NL-22-0208

Vogtle Electric Generating Plant – Units 1 & 2  
License Amendment Request for Alternative Source Term, TSTF-51, TSTF-471, and TSTF-490

**Vogtle Electric Generating Plant – Units 1 & 2  
License Amendment Request for Alternative Source Term,  
TSTF-51, TSTF-471, and TSTF-490**

**Basis for Proposed Change**

FIGURE 3.4.16-1  
REACTOR COOLANT DOSE EQUIVALENT I-131 REACTOR COOLANT SPECIFIC ACTIVITY  
LIMIT VERSUS PERCENT OF RATED THERMAL POWER WITH THE REACTOR COOLANT  
SPECIFIC ACTIVITY >1 µCi/gram DOSE EQUIVALENT I-131

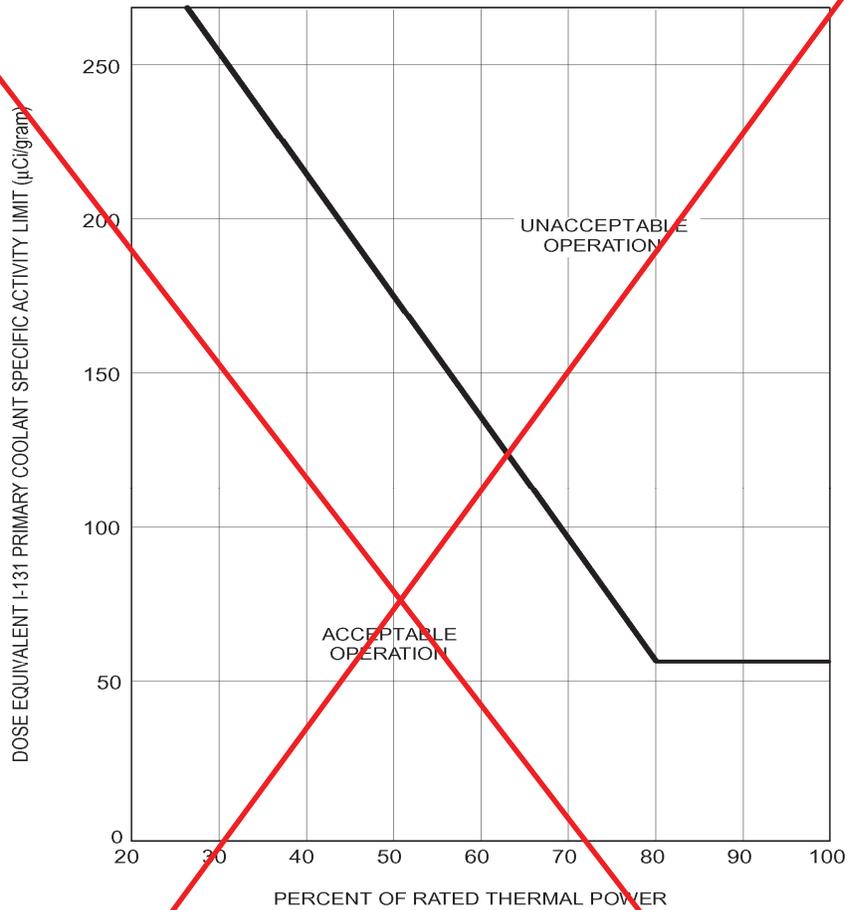
Delete Page in its entirety.
